# **SECTION 4.55(1A) MODIFICATION REPORT**

**S4.55(1A) APPLICATION TO MODIFY  
DEVELOPMENT CONSENT SSD-66826207**

**405 Pacific Highway, 5 Falcon Street &  
8 Alexander Street, Crows Nest**

**May 2025**

**Table 2: Response to ToA matters raised by DPHI**

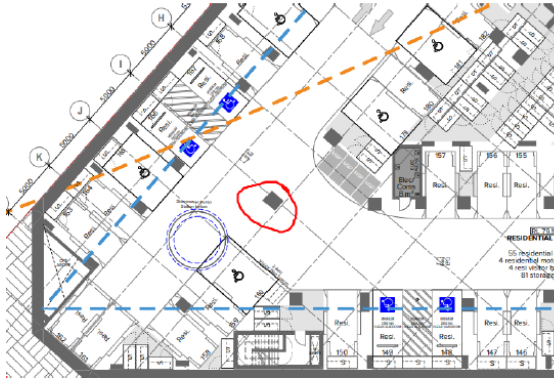
<p>A pillar has been introduced in the middle of the aisle (red circle below).</p> <ul style="list-style-type: none"> <li>• Consider deletion of this pillar for all</li> </ul>	<p>The accompanying Transport Assessment prepared by JMT Consulting (Appendix 5) confirms that the basement design</p>

levels or provide swept path templates demonstrating adequate vehicle manoeuvrability.

- There are concerns the pillar will create a blindspot to the surrounding car spaces.

maintains appropriate space for vehicle manoeuvring and passing. Swept paths around the central column indicate that a 'B99' vehicle can appropriately manoeuvre either side of the column. Refer extract of Figure 2 from the Transport Assessment below.

As part of the subsequent detailed design process, signage and line-marking will be introduced to manage vehicle movements around this column. 'Keep Left' signage would be installed on the column and pavement arrows marked to ensure drivers safely navigate this area.

**Figure 2: Approved Level 5 Basement Plan**

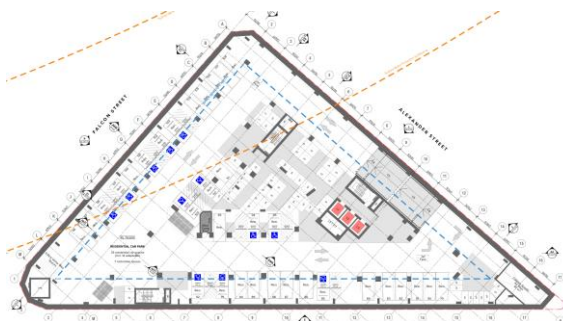
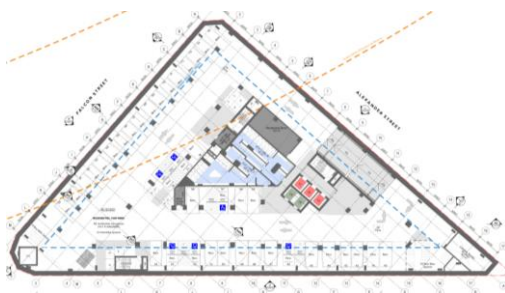
The proposed design items to be amended are indicated in the updated architectural set by Turner Studio and are summarised in Table 3 below. In summary, a detailed review of the basement layouts has occurred and has identified a more efficient allocation of parking, plant, storage and overall layout. This has resulted in the basement design being rationalised, with the deletion of two basement levels (Basement 6 & 7).

PROPOSED MODIFICATIONS		
Item	Level	Design Item
1	Basement 7	Level deleted
2	Basement 6	Level deleted
3	Basement 5	Provision of a stormwater pump station (provided at RL75.360) and sewer pump station (provided at RL75.360) below Basement 5 55 residential car spaces 4 residential motorbike spaces 4 residential visitor bike spaces 81 storage cages
4	Basement 4	50 residential car spaces 6 residential motorbike spaces 44 storage cages 4 residential visitor bike spaces 170sqm end of trip facilities
5	Basement 3	52 residential car spaces 6 residential motorbike spaces 13 residential visitor bike spaces 42 storage cages 118sqm end of trip facilities 41sqm retail store
6	Basement 2	33 residential car spaces 15 retail car spaces 1 car wash bay 6 residential motor bike spaces 7 commercial visitor bike spaces 19 residential visitor bike spaces 9 retail visitor bike spaces 21 storage cages 116sqm end of trip facilities

*Figure 19: Swept path analysis - internal vehicle circulation*

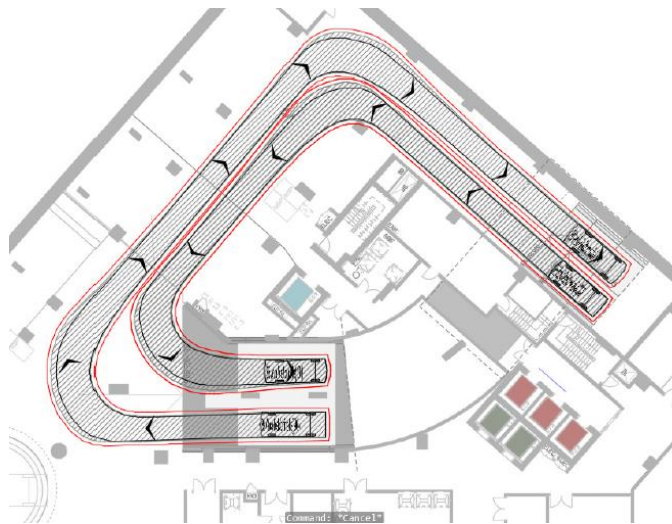
In relation to the revised car park design, the amended design is in accordance with AS2890.1 with respect to ramp gradients, circulation aisle widths and car space dimensions. A review of the plans by the traffic engineer confirms that the car park layout complies with the requirements of AS2890.1-2004 for all uses.

The basement design maintains appropriate space for vehicle manoeuvring and passing as indicated in the figure below.

Detailed swept path analysis confirming that all car parking spaces can be accessed on all basement levels has been undertaken. This confirms the car park has been designed appropriately to relevant standards and will have adequate vehicle manoeuvrability. This swept path analysis (undertaken by Turner Traffic on behalf of Deicorp) is provided as Appendix A of the accompanying Transport Statement.
